Source: Leece-Neville Heavy Duty Systems Division – Arcade, NY
Bulletin No: TSB-1210 **Date:** July 15, 2022
Models: 4800 J mount self-excite insulated return
Subject: Terminal ID from 4800 self-excite insulated to BLD4000

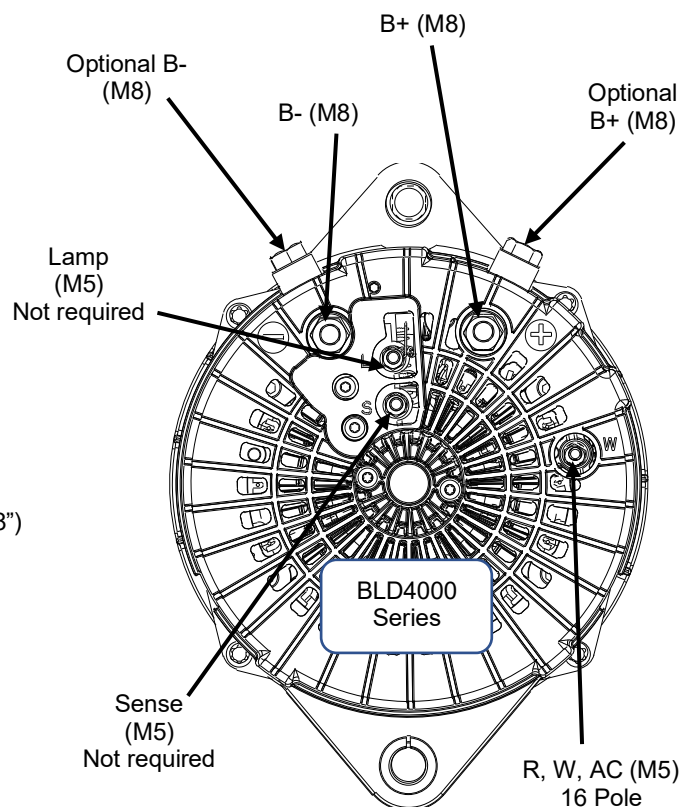
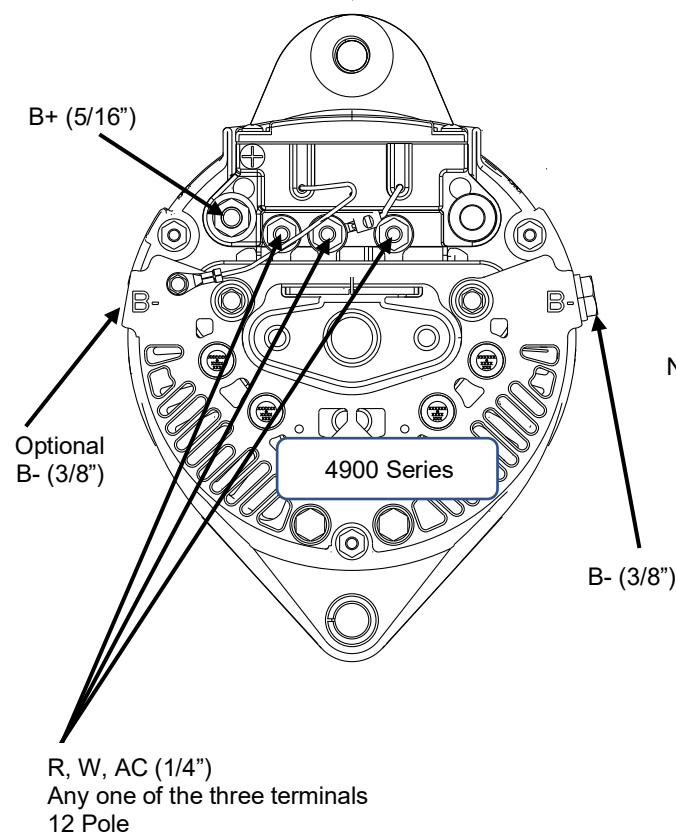
Various 4800 series self-excite brush alternators can be replaced by BLD4000 series brushless alternators. See matrix below.

This document will help identify terminal location variances.

Note: Wire termination and routing will require changes.

Sense and lamp terminals are not required on BLD4000 series for operation.
